Brockville Solar Project Renewable Energy Approval Modification Report

Final Report

June 3, 2025

Project Number:
161414291

Title
PROPOSED GRADING PLAN

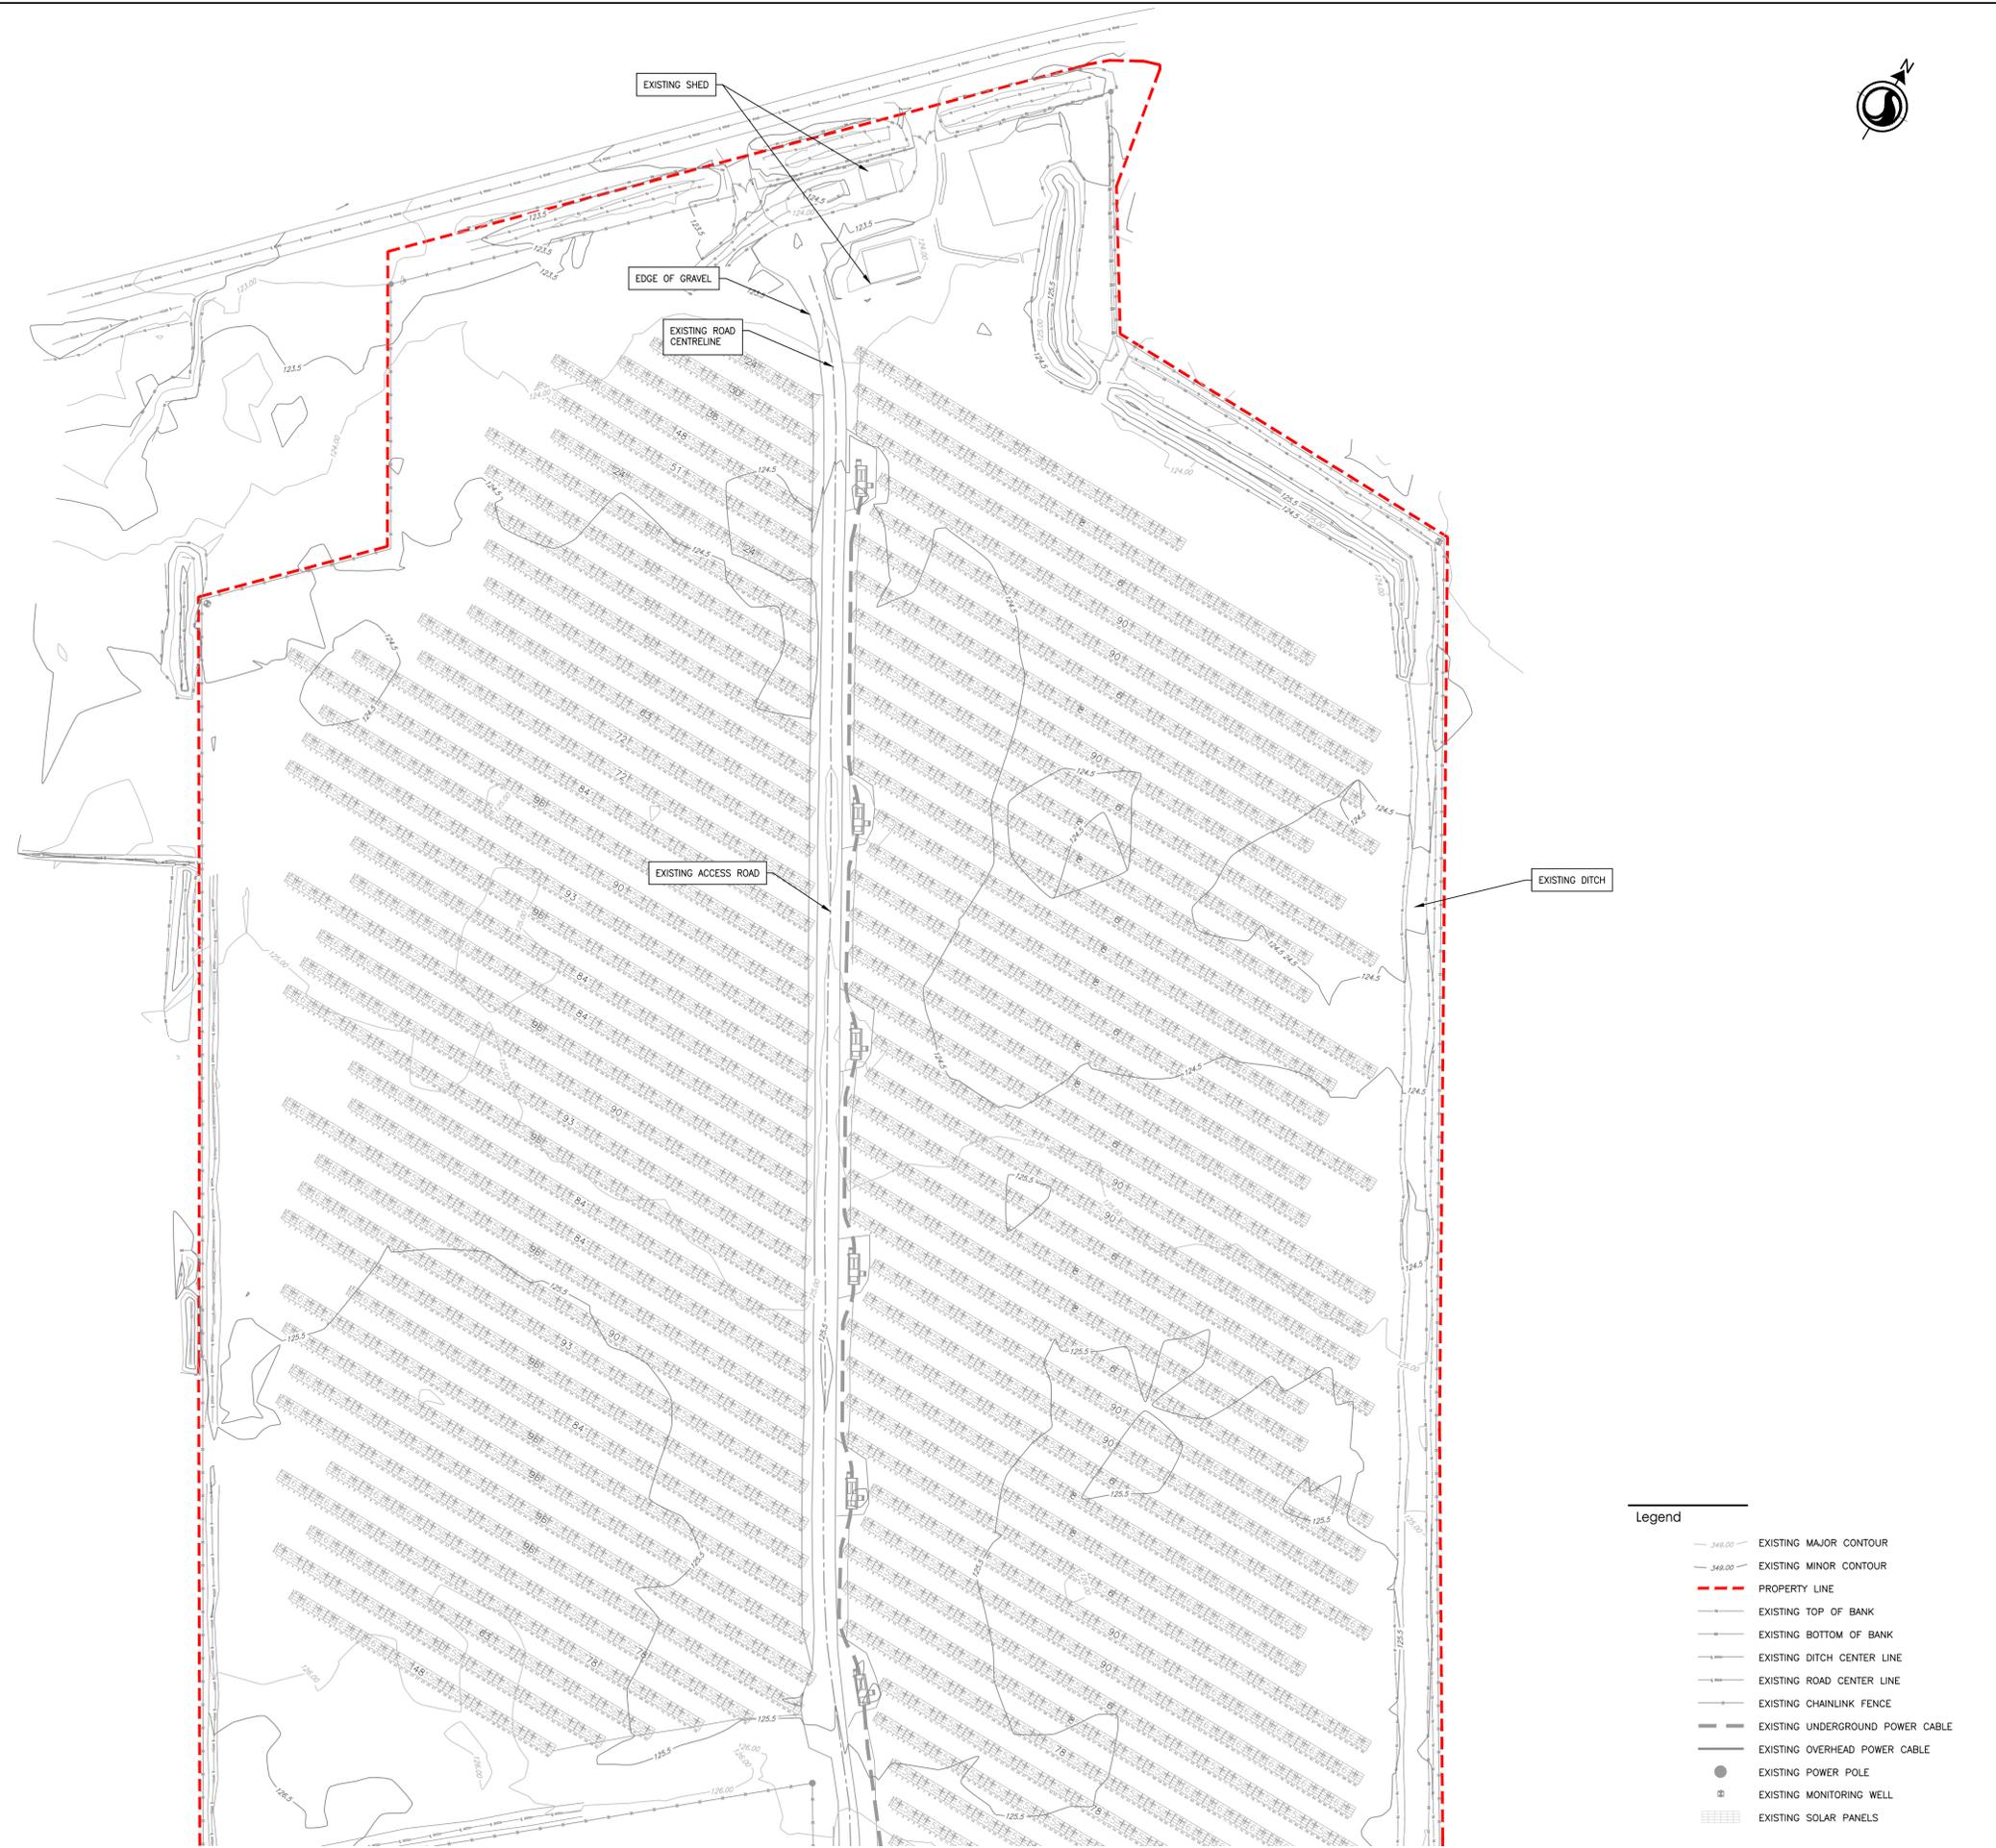
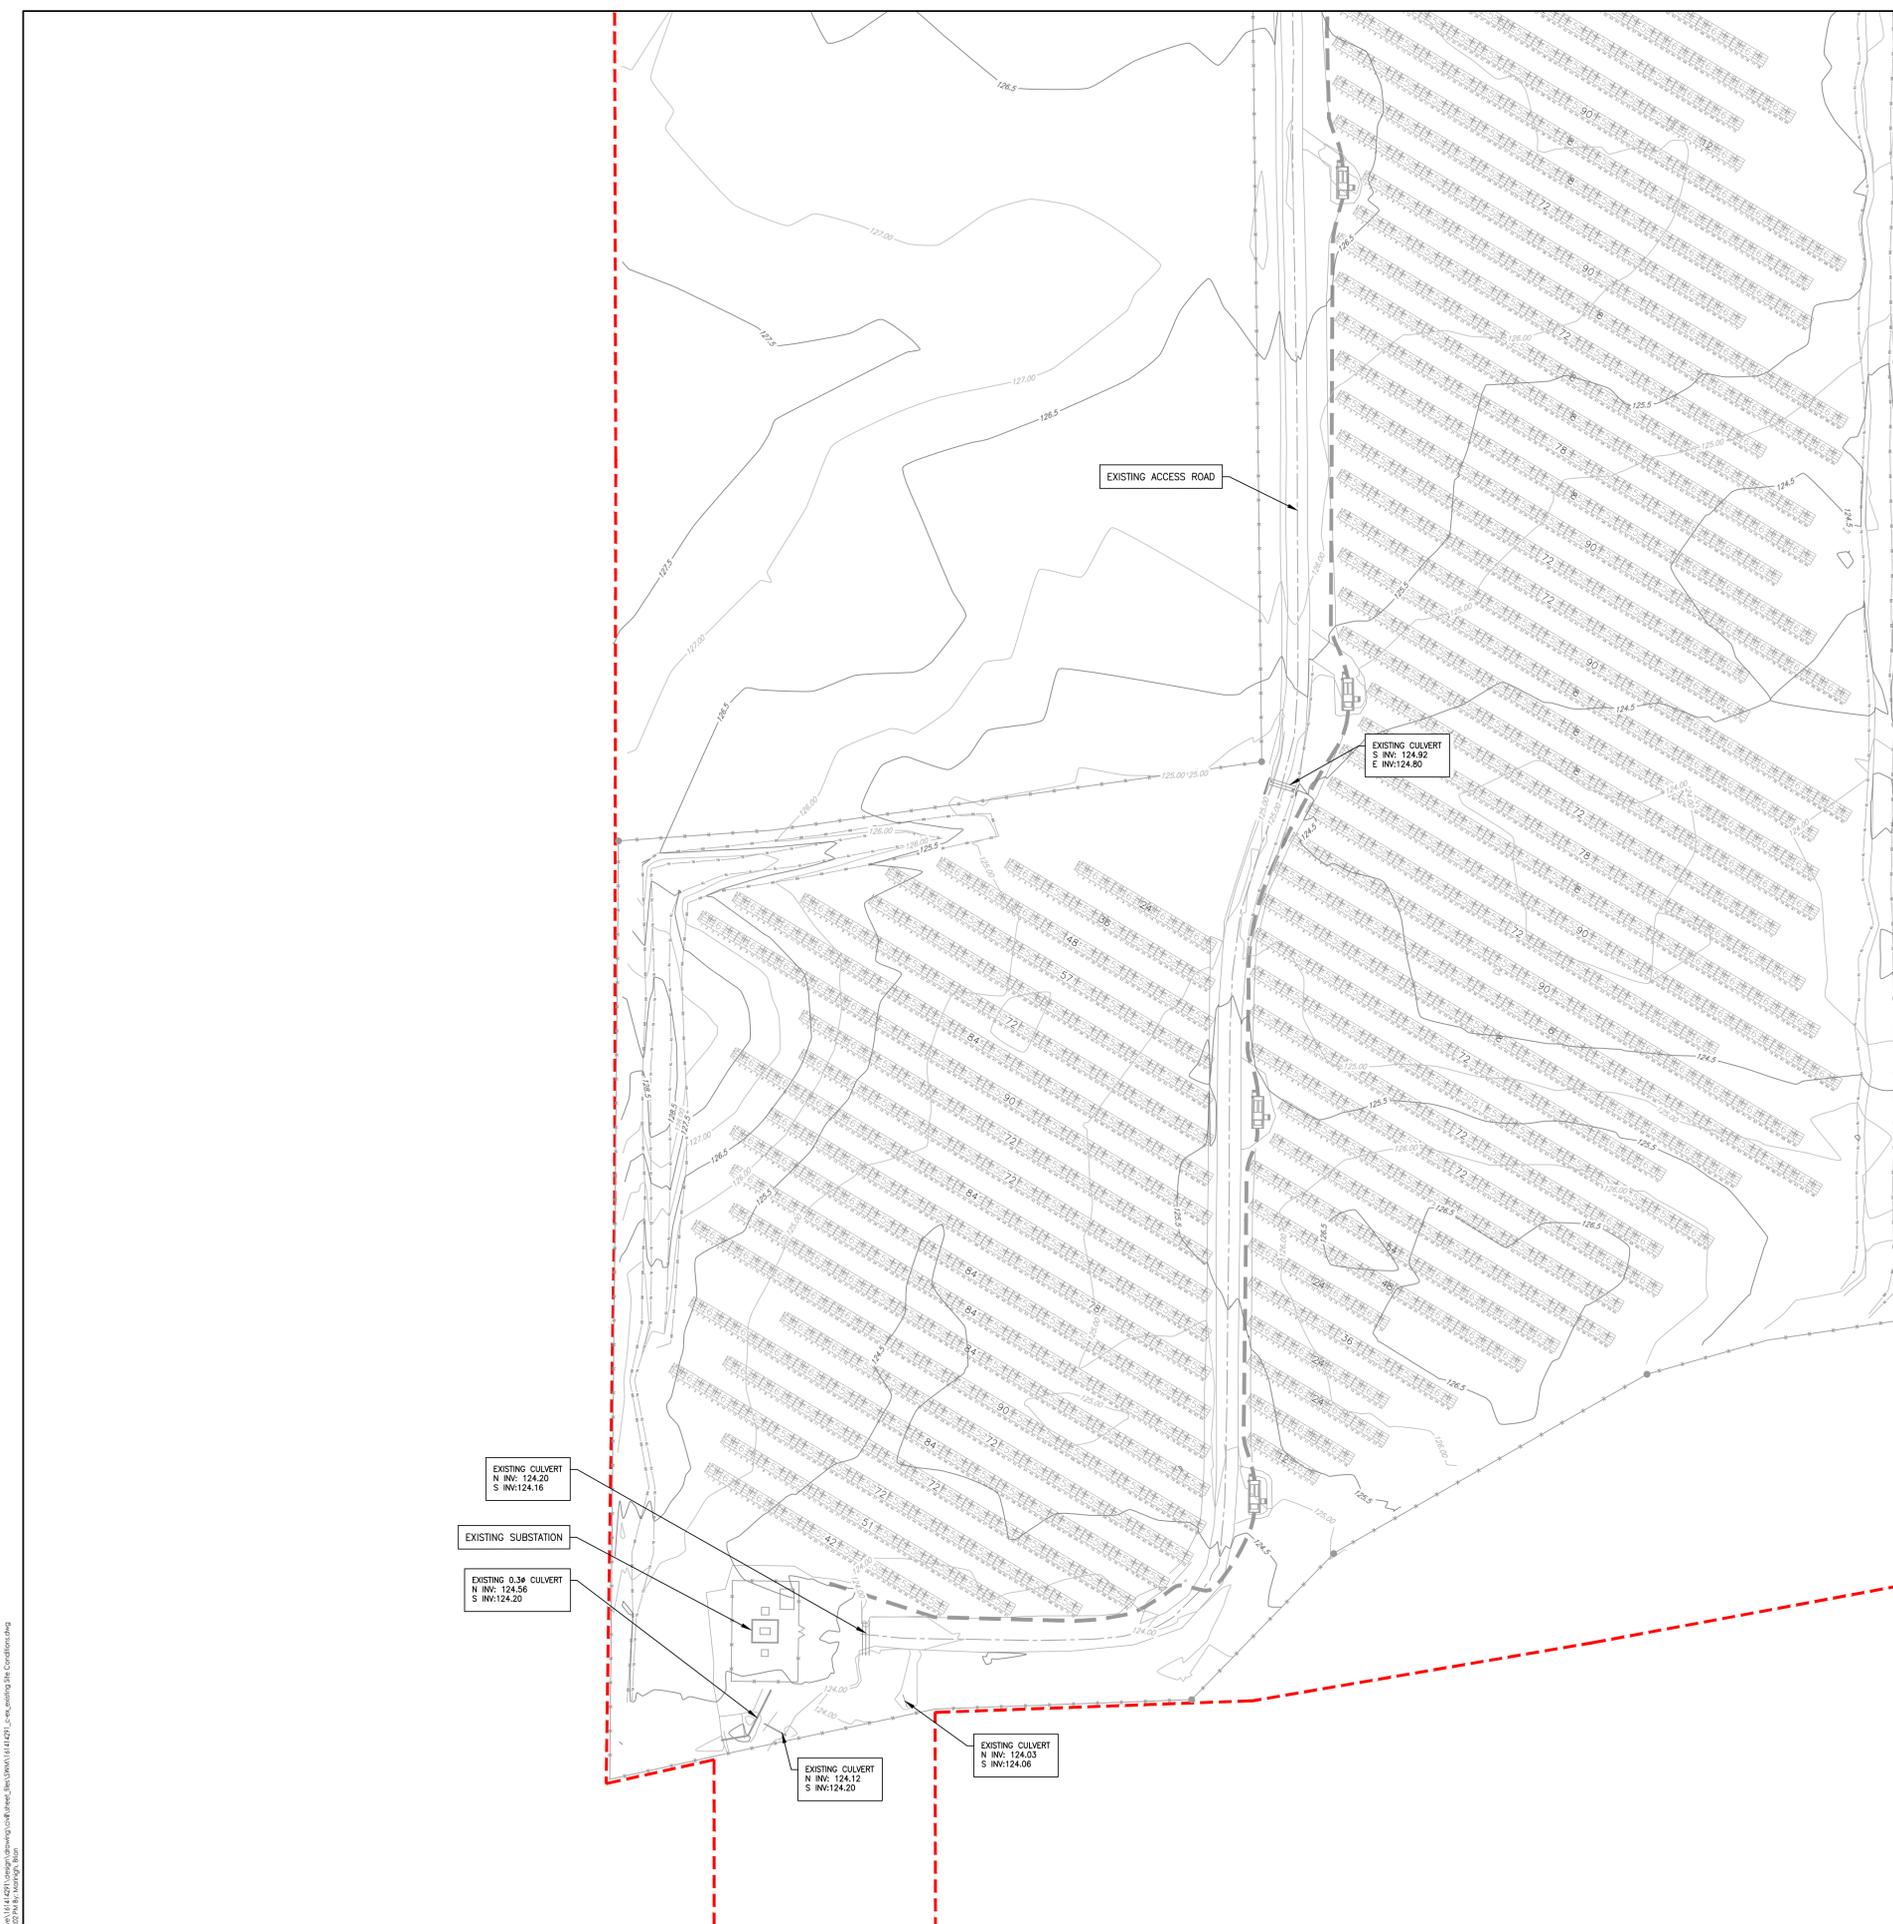
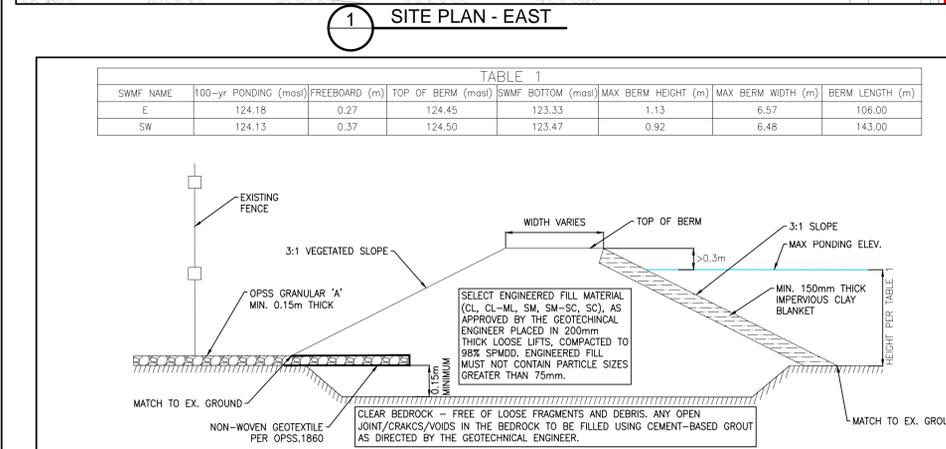
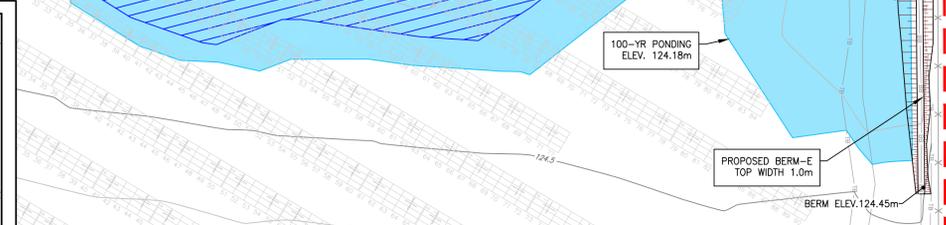
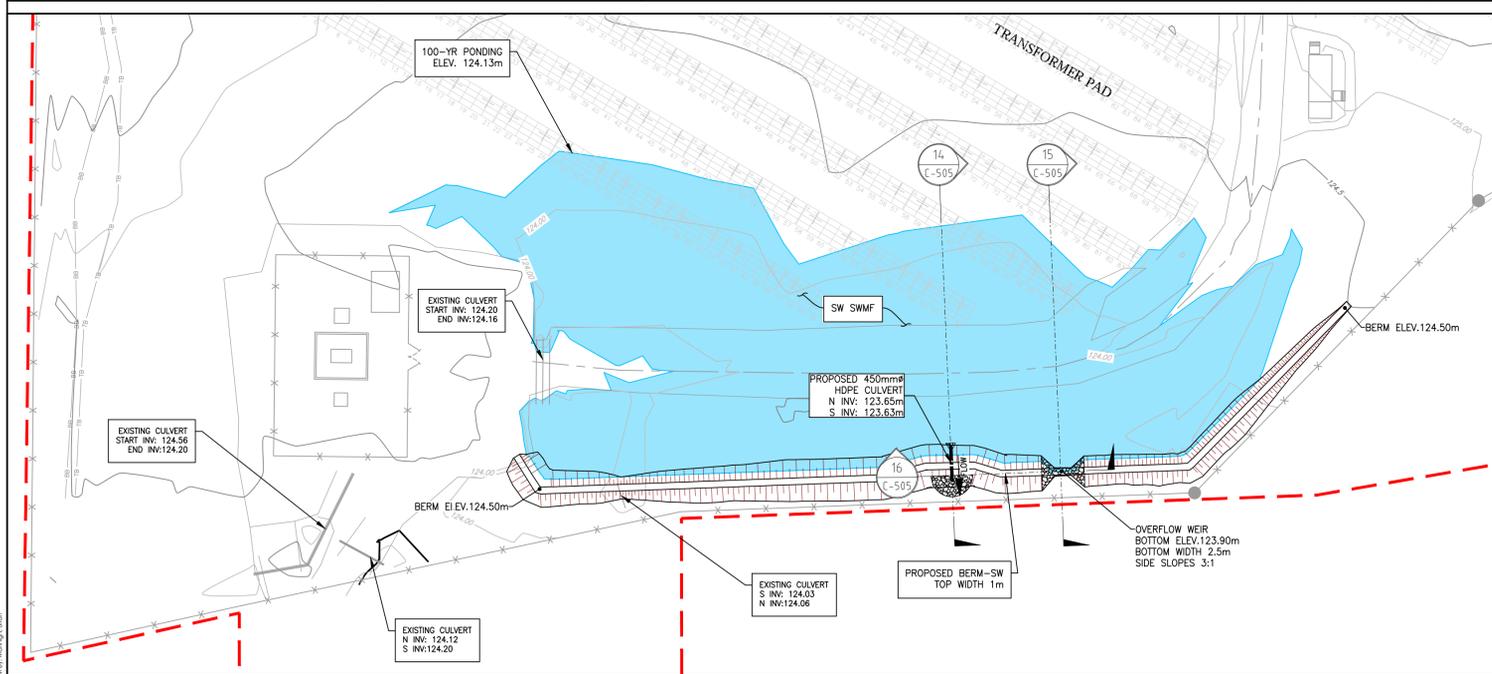
To support the technical change, an updated SWM design completed by Stantec (Appendix D) will aim to reduce the use of any excavated materials by using a combination of berms and outlet controls to provide shallow detention basins that will provide on-site water quantity control for the Project.

The original site plan can be found in Appendix B, followed by the revised site plan with the proposed changes in Appendix C.

The proposed technical change is an updated SWM design aimed to modify the approved stormwater management plan by reducing need for significant excavation and using a combination of berms and outlet controls to provide the required water quantity control for the Project. The proposed controls will all be along the perimeter of the site and in the Project Property Line. In addition, there will be the installation of a back-up generator to provide station service support in the event of a power outage where the Project does not receive power from the grid.
